PRCOM20224906

REVISDE 6/22/2023

I-470 BUSINESS & TECHNOLOGY CENTER, LOT 7

ISSUED FOR PERMIT OWNER REVISIONS

SITE WATER PLAN

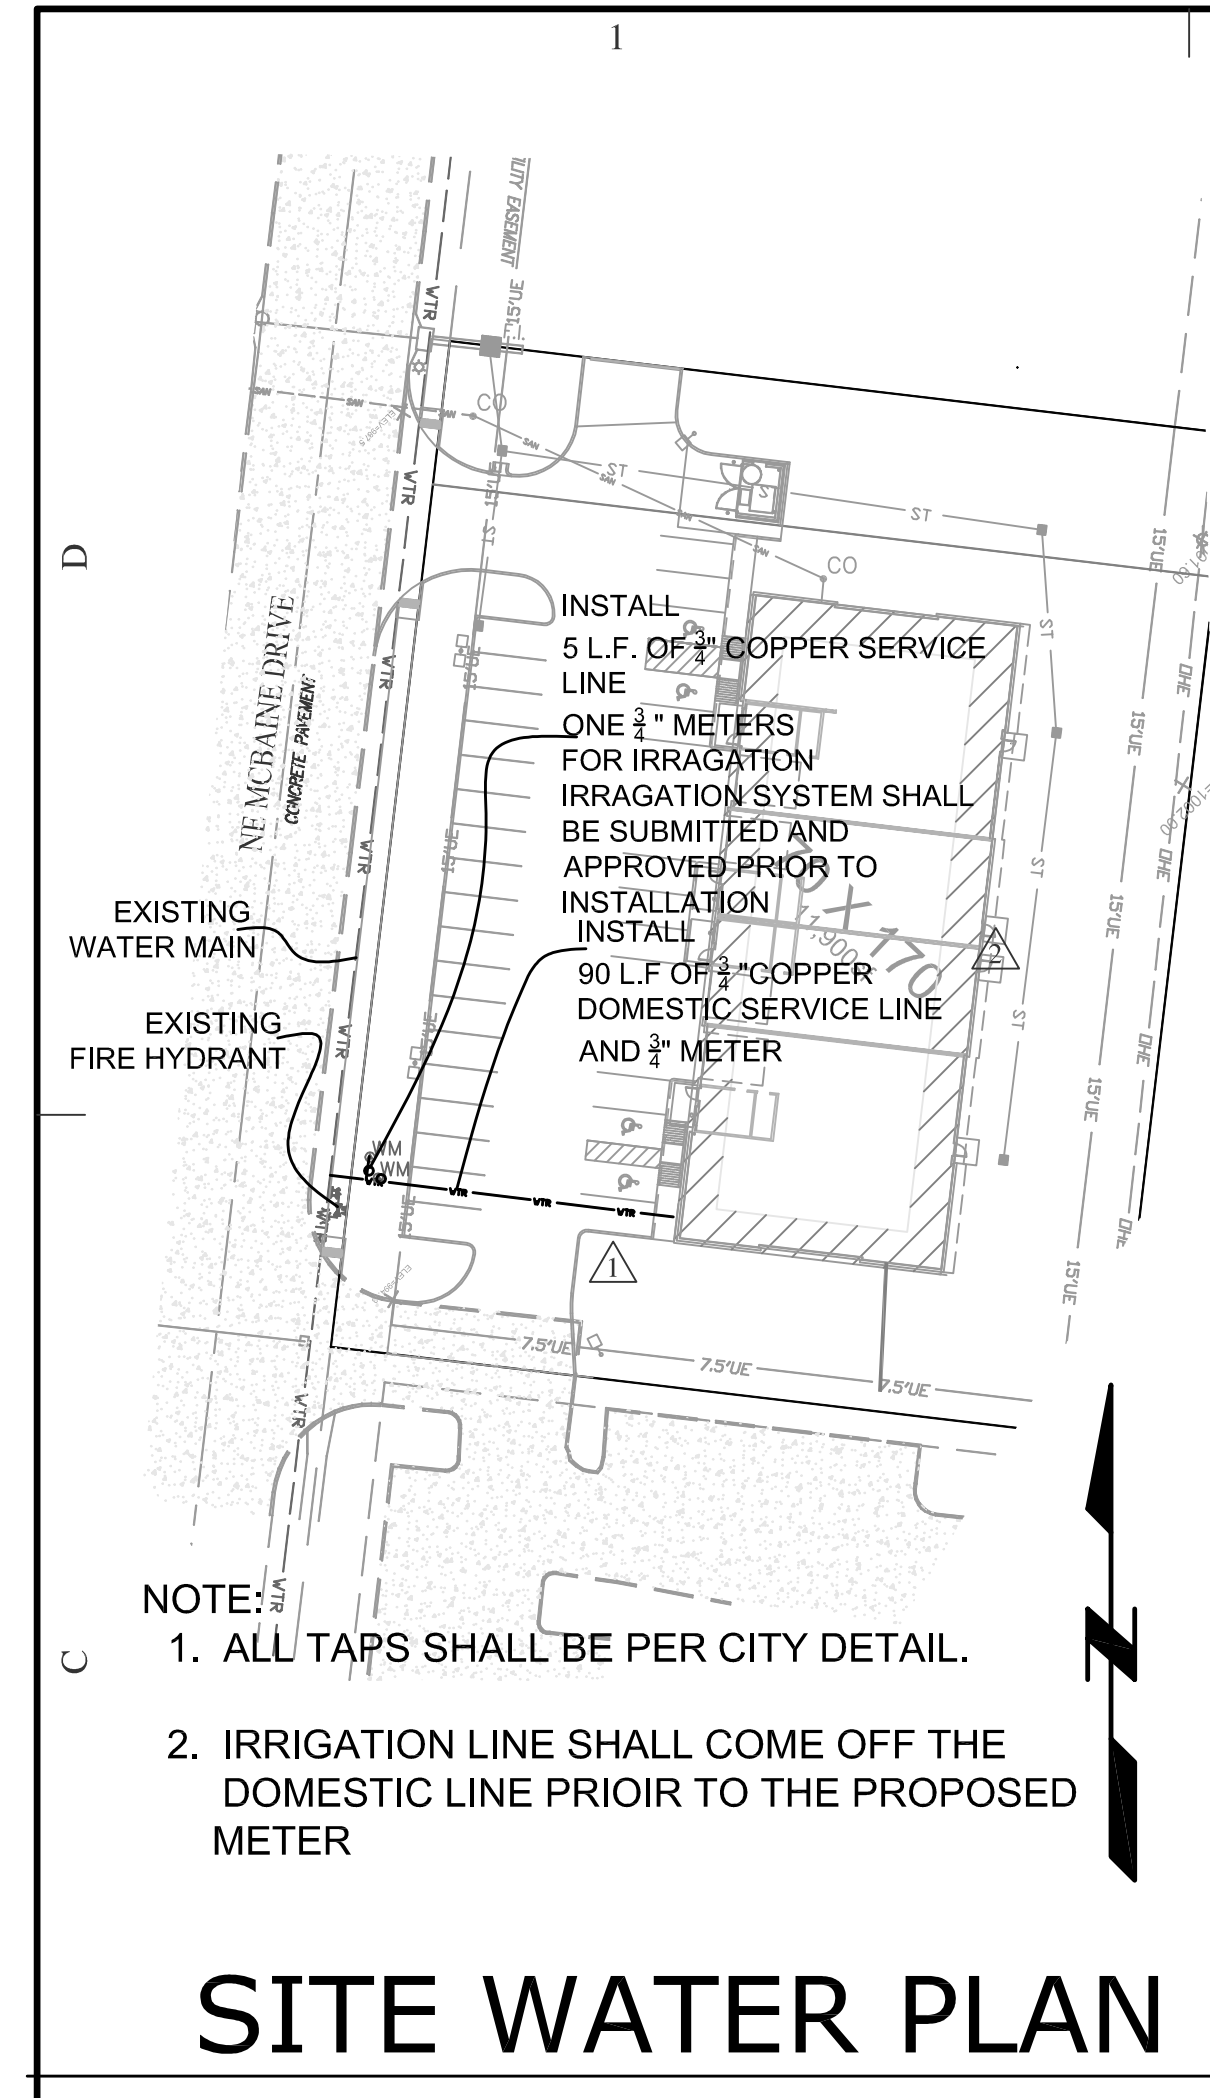
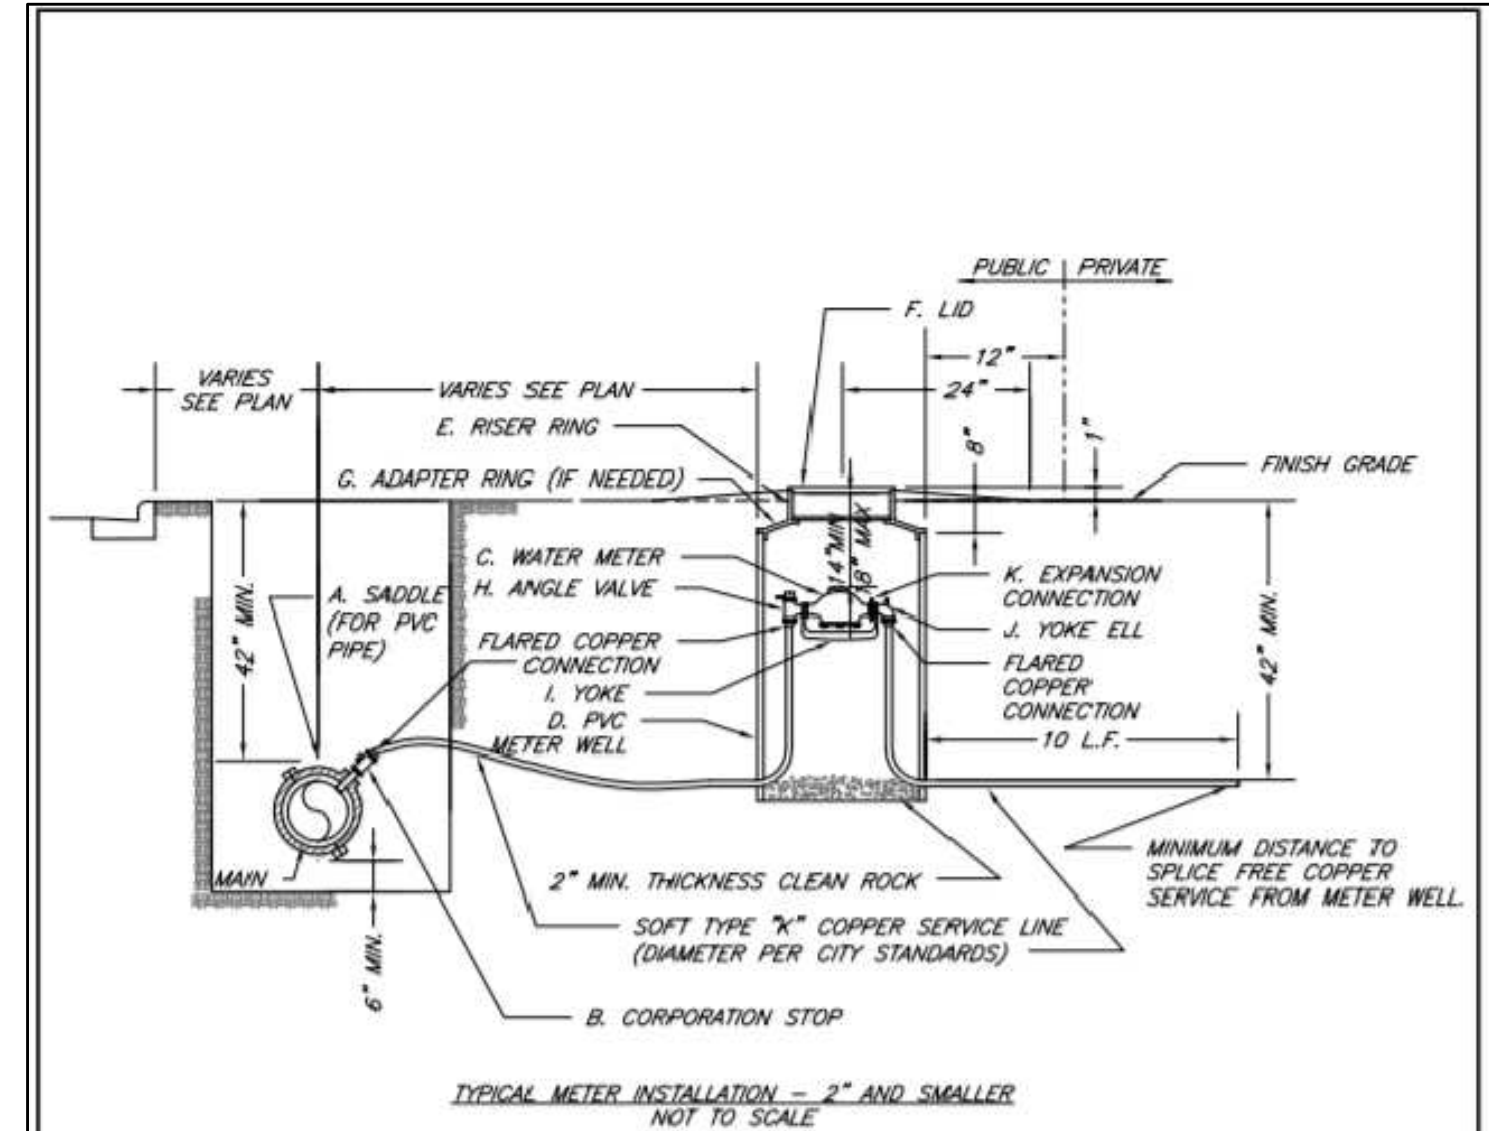
△ 6-22-23 - REMOVED REAR ACCESS ROAD, RELOCATED TRASH ENCLOSURE REVISED PARKING ALONG FRONT OF BUILDING

- △ ADDED LINE MATERIAL 12-14-22
- △ REMOVED FIRE LINE 11-17-22
